ADDENDUM #1

October 1, 2026

2027 Roof Replacement at Thomas Elementary School
Dublin City School District Board of Education
4671 Tuttle Road
Dublin, Ohio 43017

Mays Project #: DOH43-012-03

Sheet No.: A1.1

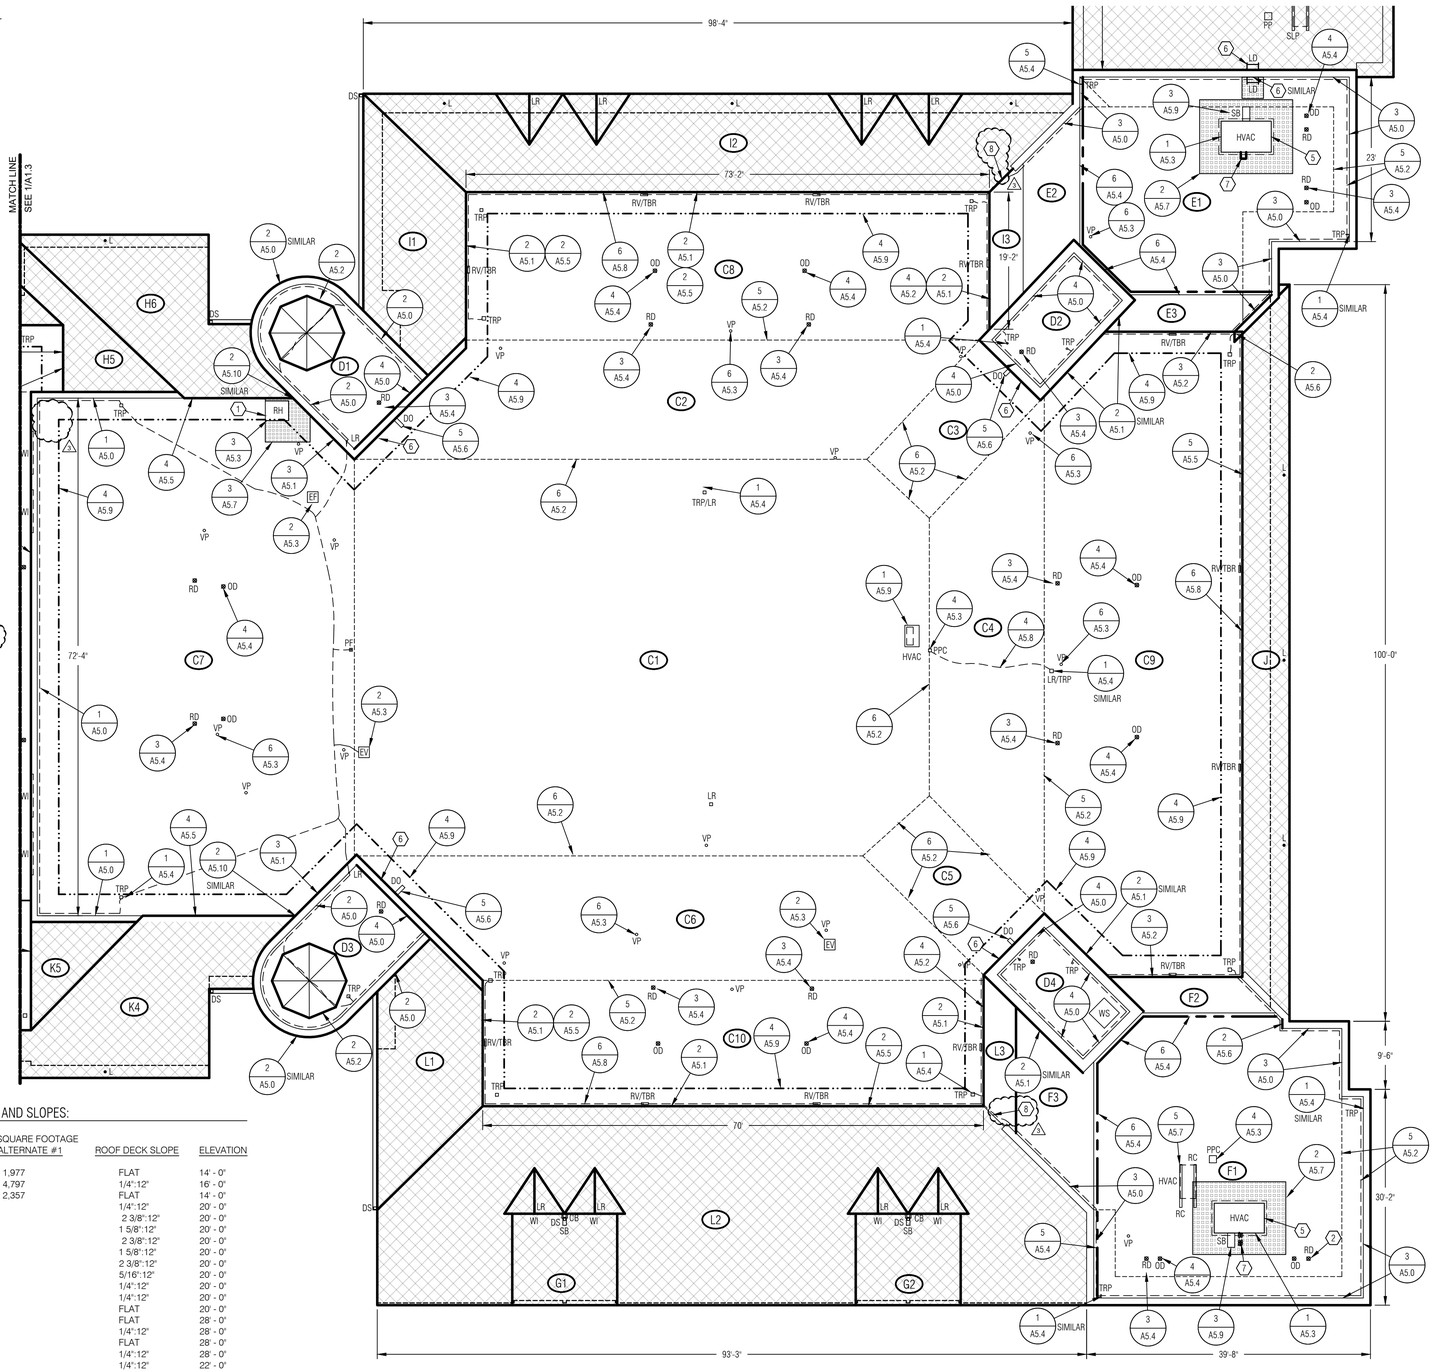
7. A requirement was added to construct a short parapet wall between Roof Areas L2/L3 and I2/I3. See new coded note #8 on Drawing Sheet A1.1.

8. An incorrect coded note was deleted from Drawing Sheets A1.1 and A1.2.

9. A note was added to Drawing Sheets A1.1 and A1.2 clarifying the "existing" components that are to remain and new work items.

△1 12. IN THE PROJECT DETAILS, ITEMS THAT ARE GRAY SHADED AND LABELED AS "EXISTING" ARE INTENDED TO REMAIN IN PLACE AND NOT BE MODIFIED AS PART OF THE PROJECT. NON-SHADED ITEMS ARE TO BE NEW WORK.

△1 8. BASE BID - CONSTRUCT 12" HIGH PARAPET WALL AT THIS LOCATION FROM THE EXISTING PARAPET WALL TO THE HIGH SIDE OF THE ROOF TO SEPARATE THE STEEP SLOPE SHINGLE ROOF FROM THE ADJACENT THERMOPLASTIC MEMBRANE ROOF AREAS. THE WALL SHALL BE THE SAME WIDTH AS THE EXISTING PARAPET WALL AND SHALL BE SHEATHED WITH 5/8" FRT PLYWOOD ON BOTH SIDES. MODIFY THE OUT OF SCOPE SIDE OF THE WALL BY INSTALLING SELF-ADHERING UNDERLAYMENT ON THE FACE OF THE WALL, APRON FLASHING TRIM, AND SHEET METAL FLASHING AS NECESSARY TO FLASH AND SEAL THE OUT OF SCOPE PORTION OF THE WALL.

Sheet Name: OVERALL ROOF PLAN - ELEVATION CALLOUTS

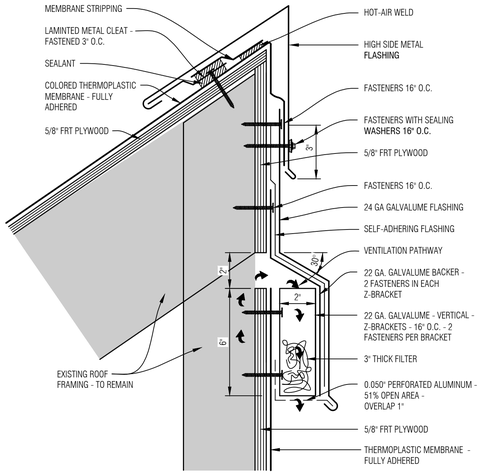
10. A non-relevant coded note was deleted from Drawing Sheet A2.0.

1 / A5.2

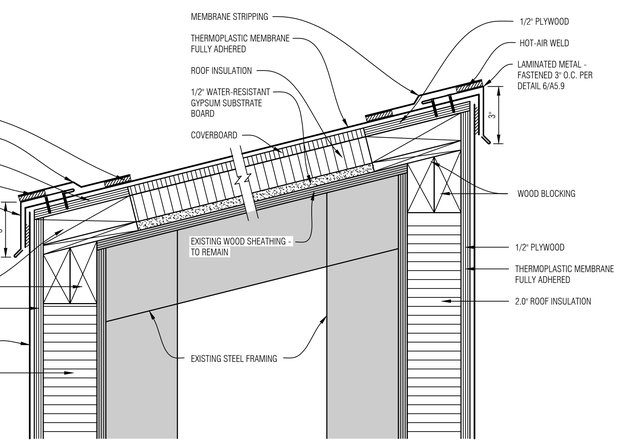
11. The door sill flashing component was clarified in Detail 1/A5.2.

1. SELF-ADHERING FLASHING AT DOOR SILL TO BE TURNED UP JAMBS 3" MINIMUM TO FORM AN END DAM.
